This kit (A37705-021) contains the parts needed to change from a metal drip pan to a plastic one.

Drip Pan Position

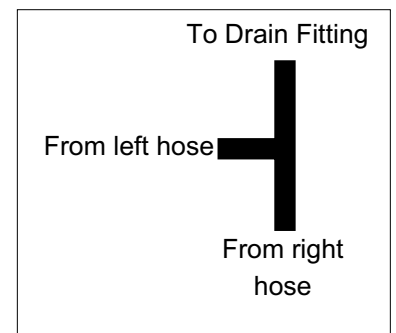
1. Remove metal drip pan and cork gasket from ice machine.
2. Remove and discard the original drip pan drain tubing.
2. Place new cork gasket on gear box cover. Be sure all old gasket material has been removed.
3. Place new drip pan onto gear box cover. Position it so that the drain hole is to the right of the gearbox.

02-3826-02, for
left side of 42"
wide units

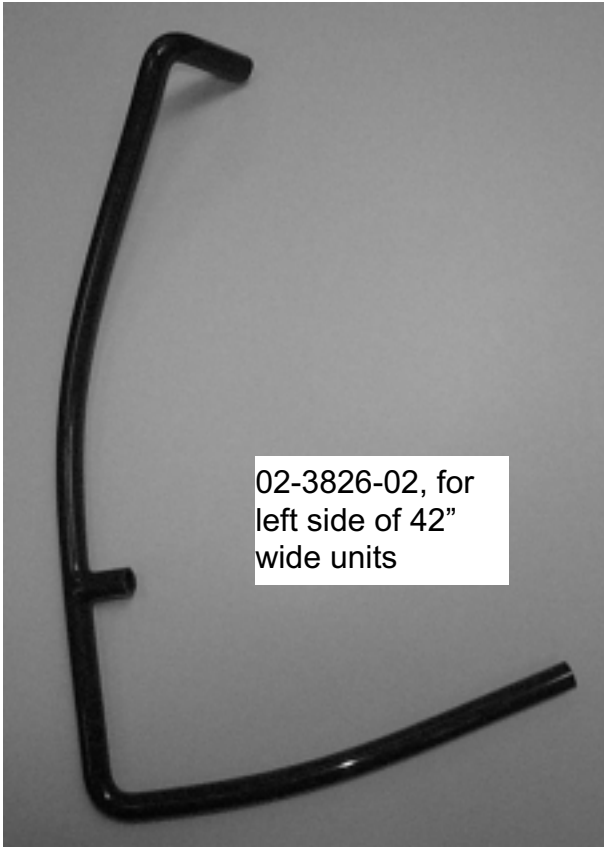
4. Secure the evaporator to the gear box with the original bolts.
5. Select the proper drain hose (see back page)
 - FM800, FME800, NM650, NME650, FM1202, NM952, FM1200, FME1200, NM950, NME950 use 02-3826-01.
 - FM2400, FM2402, FME2400, NM1850, NM1852, NME1850 use 02-3826-01 for the right side and 02-3826-02 on the left side.
 - FM1500, FME1500, NM1250, NME1250 use 02-3836-01.

02-3826-01, for 21"
wide units and right side
of 42" wide units.

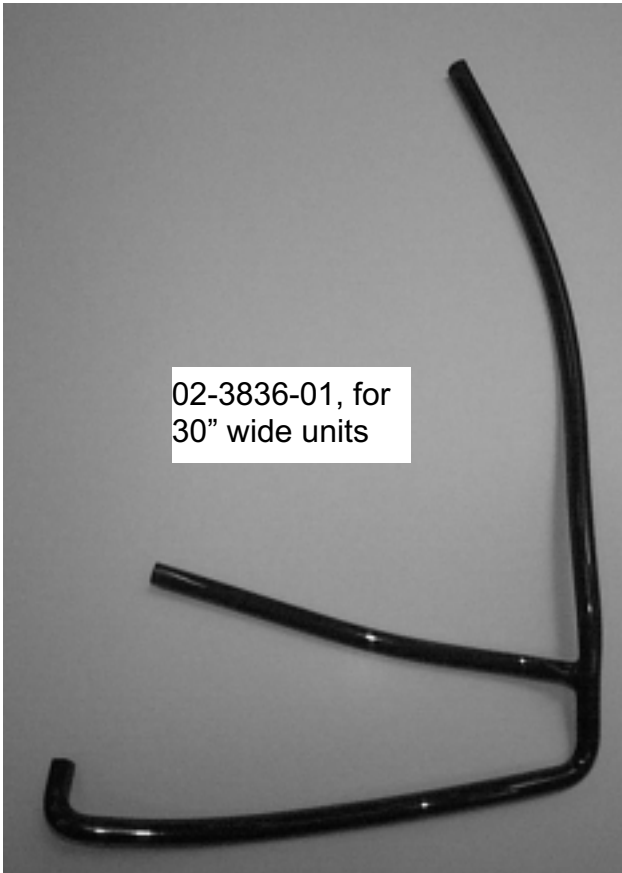
Note: Cut 3" from this part of the
hose when using it on FM800,
FME800, NM650, NME650
